Mark B. Bezilla
Site Vice President724-682-5234
Fax: 724-643-8069December 2, 2002
L-02-115U. S. Nuclear Regulatory Commission
Attention: Document Control Desk
Washington, DC 20555-0001**Subject: Beaver Valley Power Station, Unit No. 1 and No. 2
BV-1 Docket No. 50-334, License No. DPR-66
BV-2 Docket No. 50-412, License No. NPF-73
Response to a Request for Additional Information in Support of
License Amendment Requests Nos. 300 and 172**

Attachment A to L-02-115
Responses to November 22, 2002, RAI Section 1.0 - Enclosure 2

NRC Request for Additional Information

Figure 4.1-4
Composite Figure of the containment Pressurization and Gas Atmosphere Temperature Histories for the DEHL Analyses in the Three Different Loop Compartments for BVPS-1

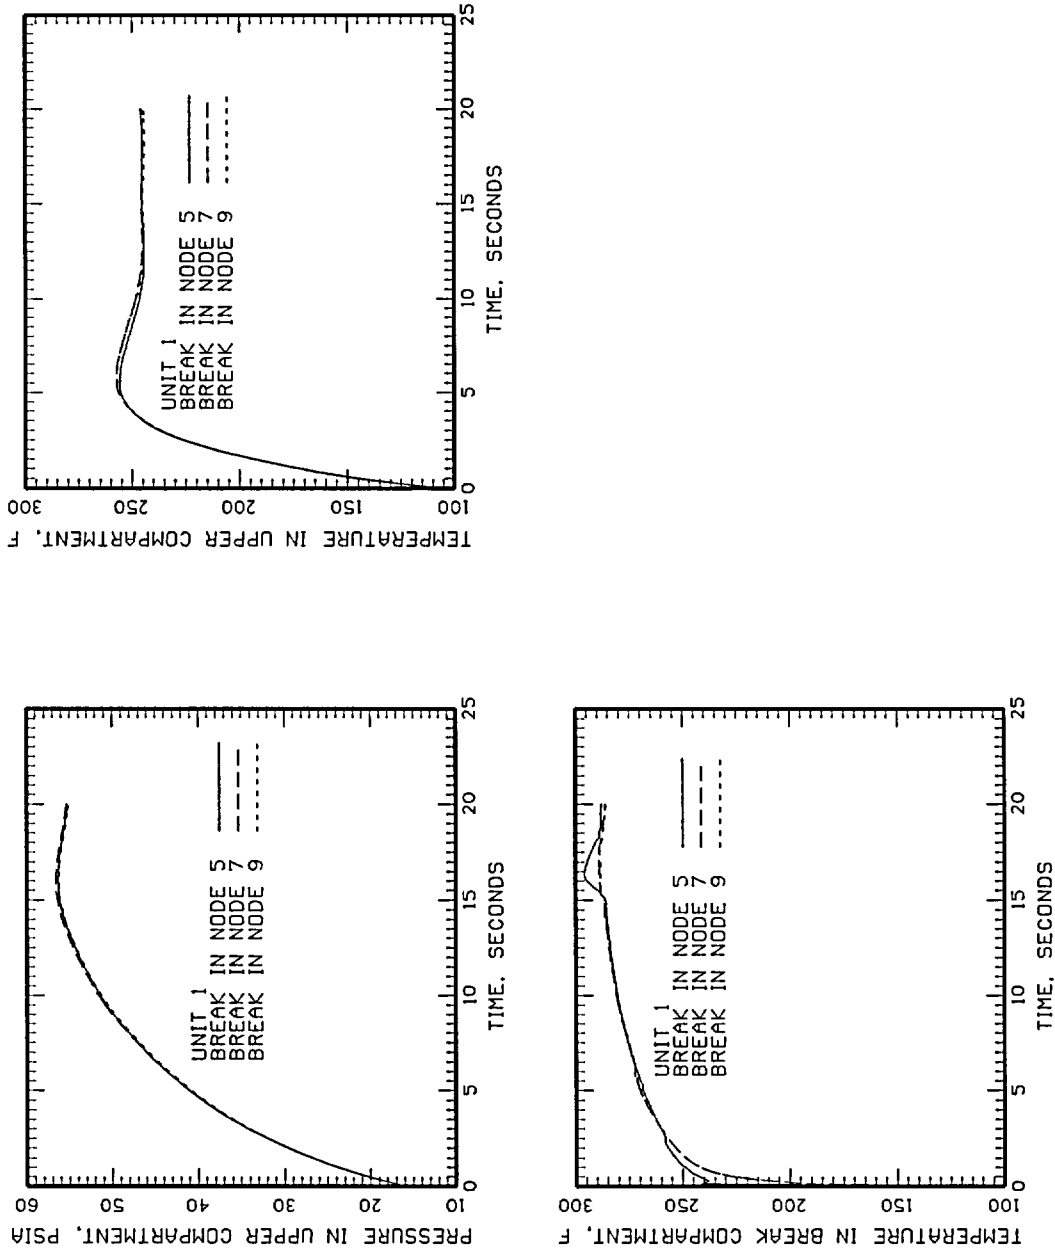
Item 1.2.2. Why is the upper containment initial pressure shown in Figure 4.1-4 below the maximum initial pressure specified in Table 4.1-3?

The Figure 4.1-4 ordinate scale is incorrect. The values should be shifted up by 5 psi to properly represent the calculated response for this case. The initial pressure used for the reported results was the maximum initial pressure specified in Table 4.1-3. A corrected version of Figure 4.1-4 is provided.

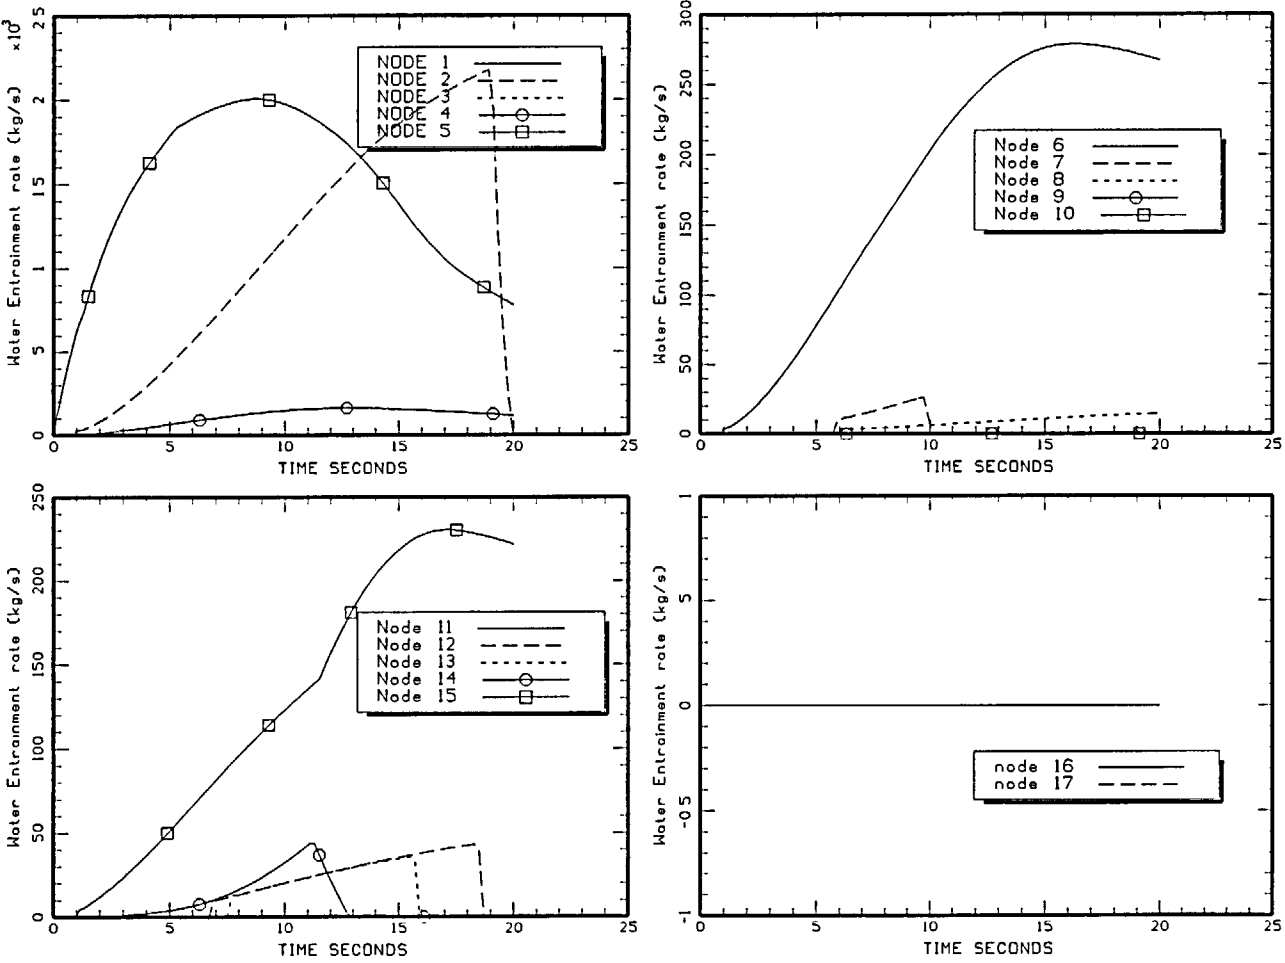
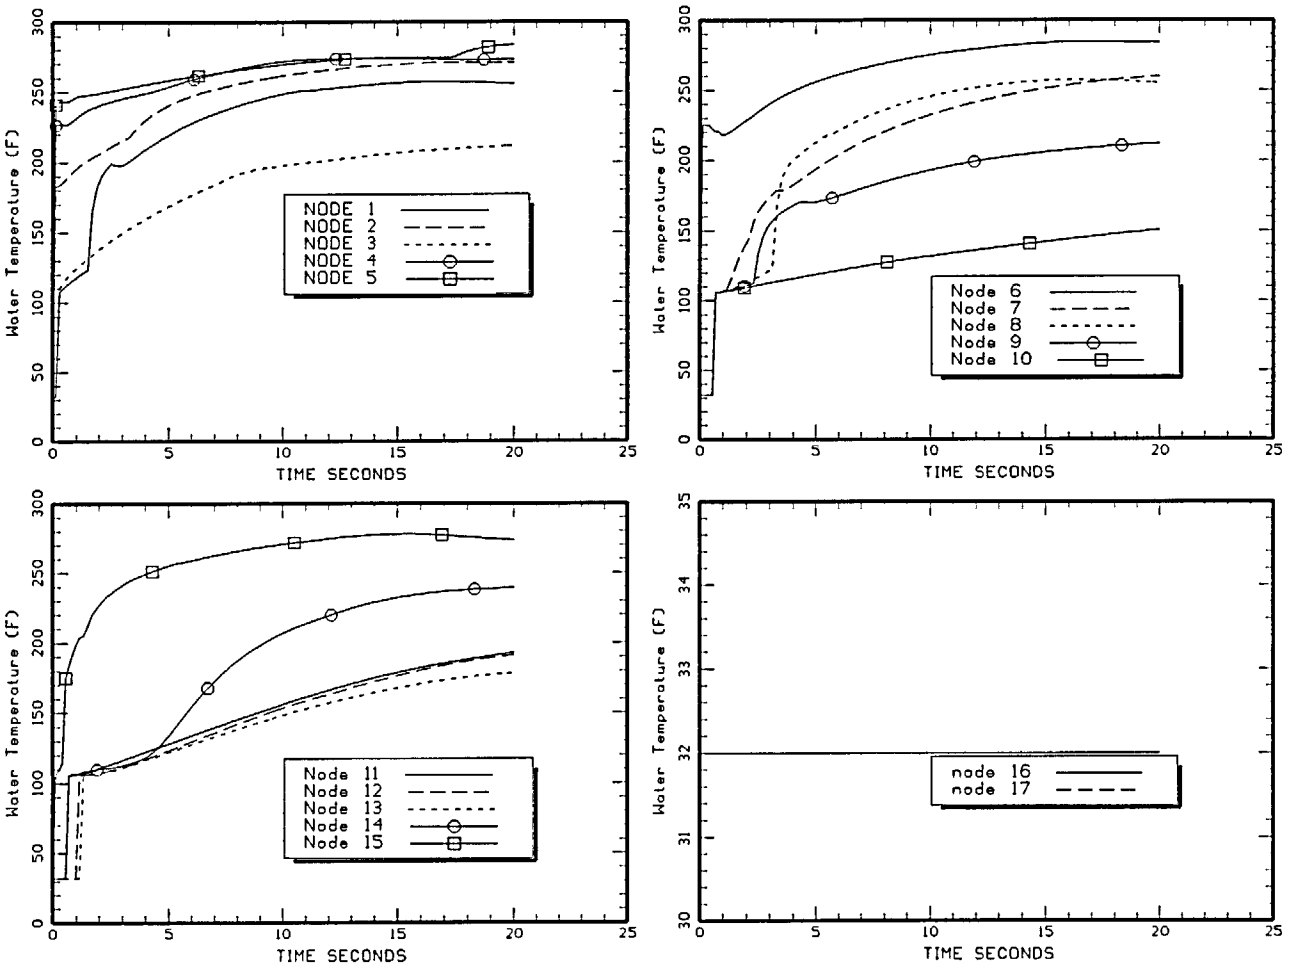
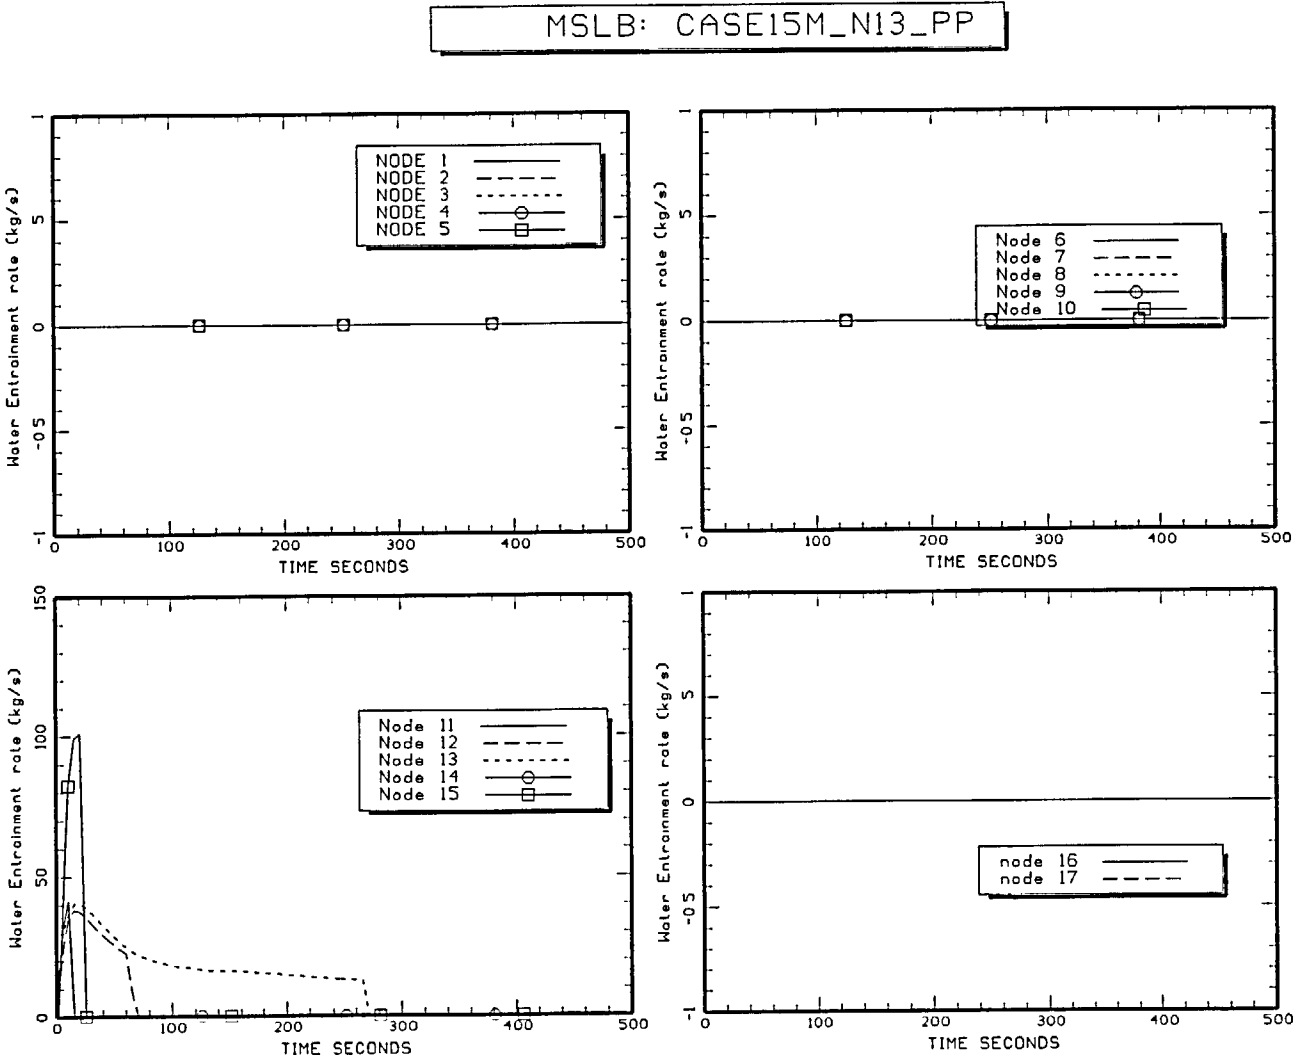
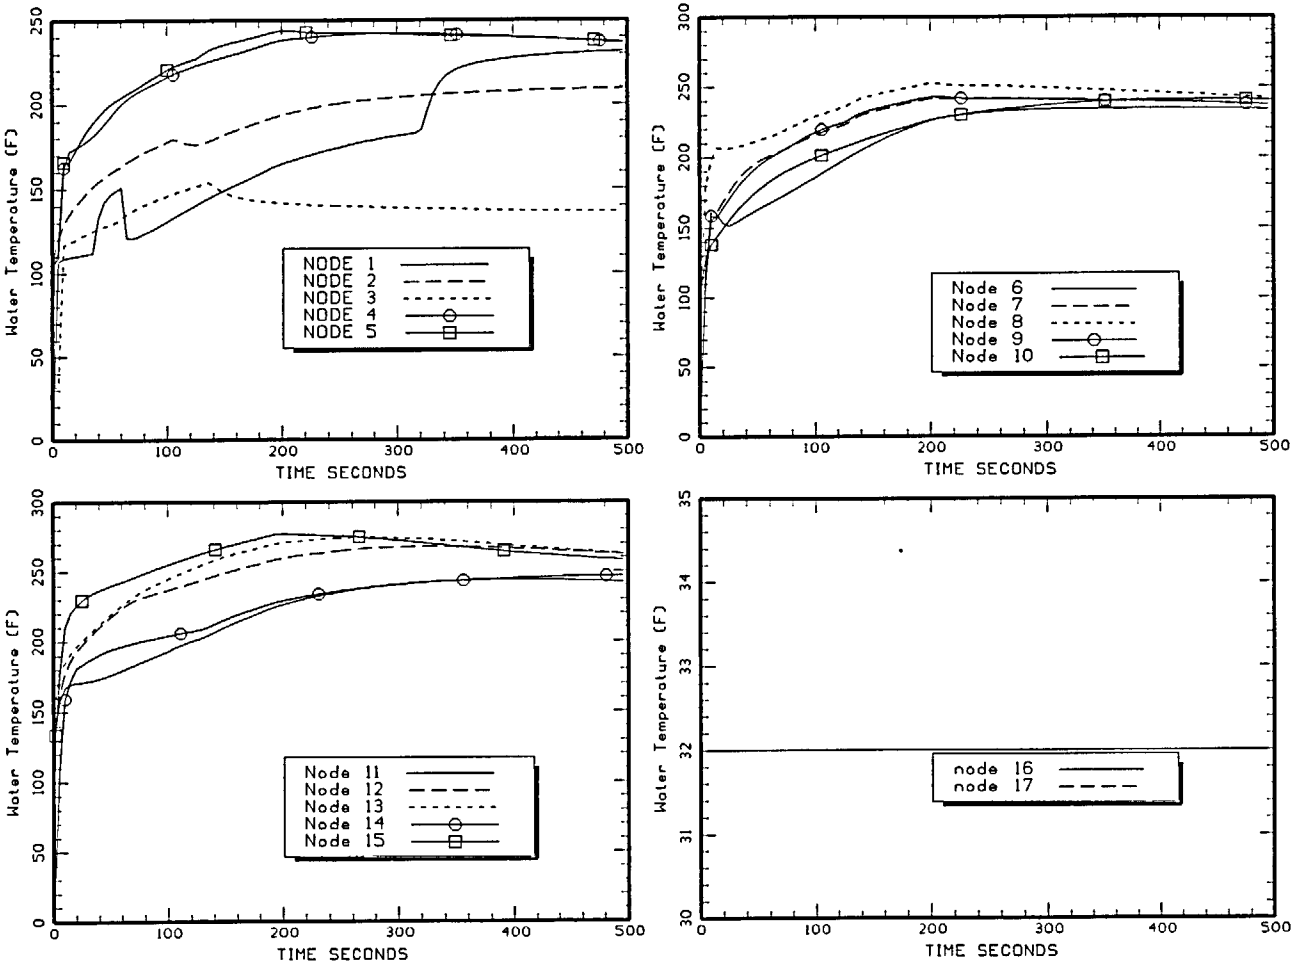
Item 1.2.4. Show water entrainment and pool temperature profiles in containment compartments for representative MSLB and LOCA calculations

The water entrainment rate and sump water temperature profiles are provided for two representative sequences. The large LOCA sequence is the double ended hot leg break (case 8L-5_PP; Figures 12 and 13) and the MSLB case (case 15M_N13_PP) with the results shown in Figures 14 and 15. Water pool temperatures in Nodes 16 and 17 are the default values since there are no floors for these nodes, and therefore, no water mass.

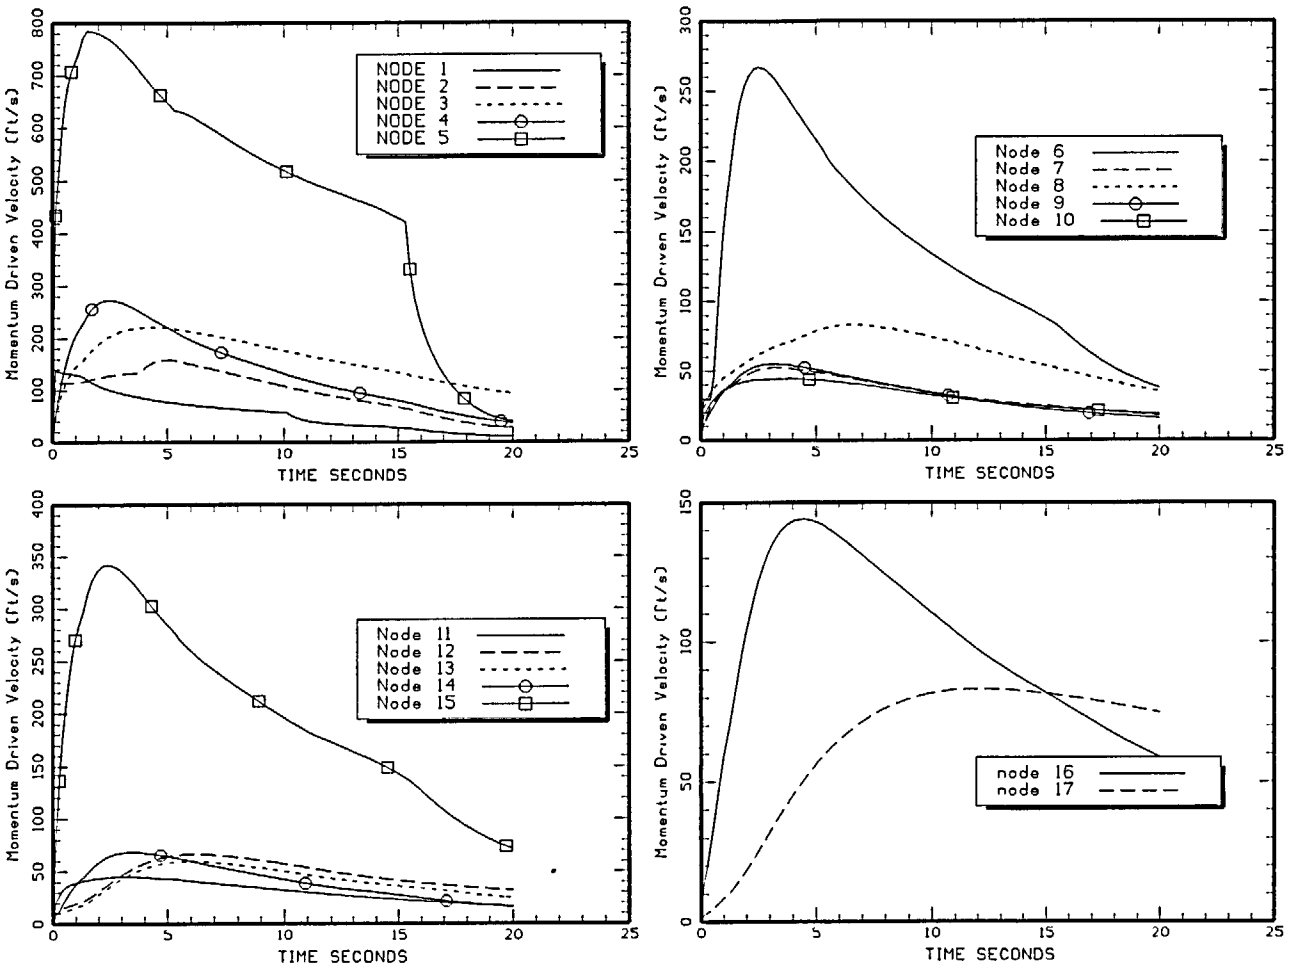
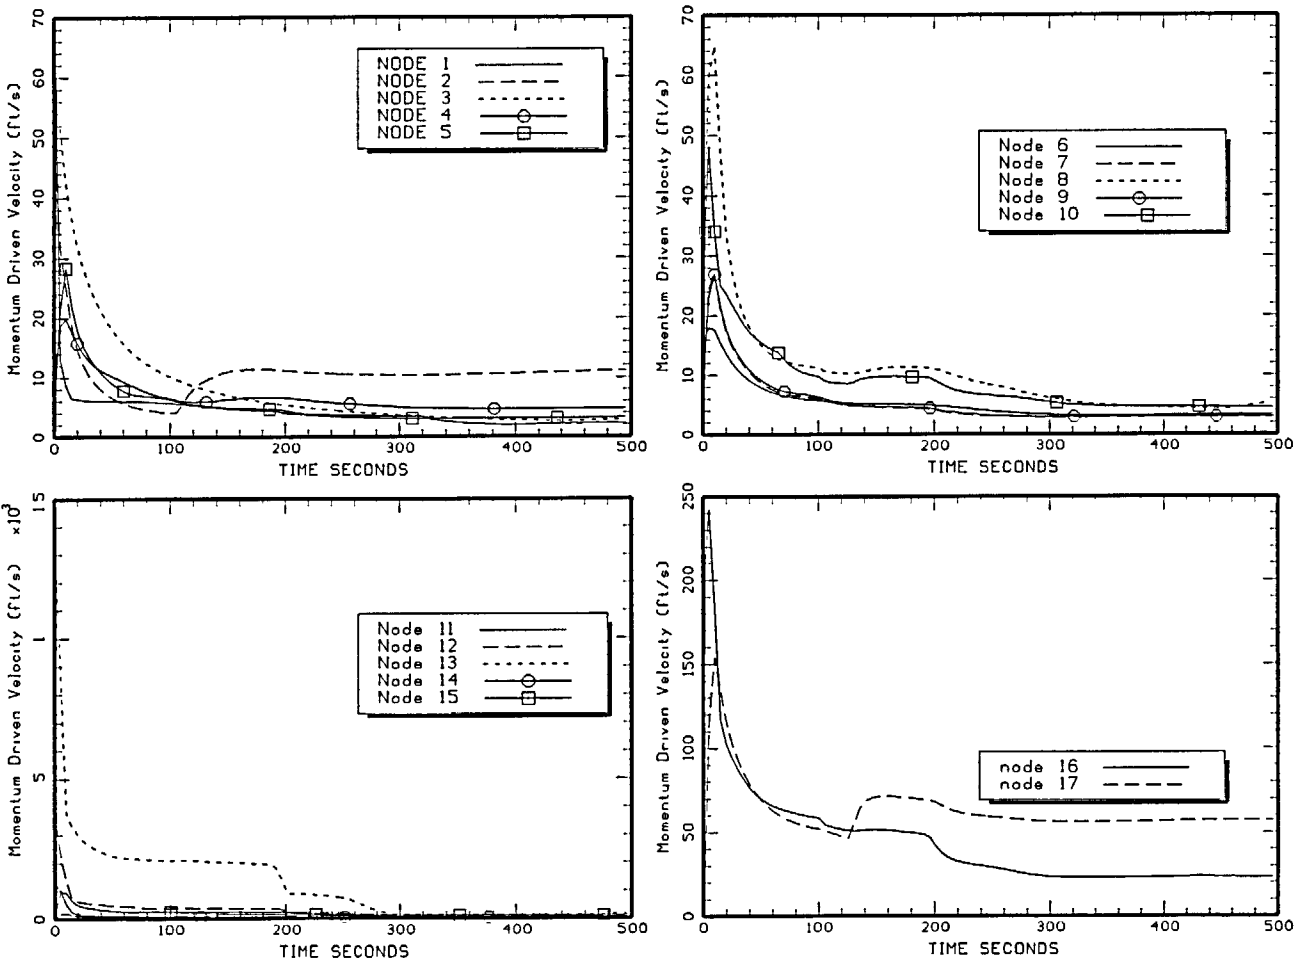
Item 1.2.5. Provide MAAP5 momentum-driven velocity time history profiles for compartments using representative MSLB and LOCA cases (as above).

The MAAP5 momentum-driven transient velocities for all containment nodes are provided in the attached Figures for the two representative sequences. The large LOCA sequence is the double ended hot leg break (case 8L-5_PP) and is shown in Figure 16 and the MSLB case (case 15M_N13_PP) is shown in Figure 17.
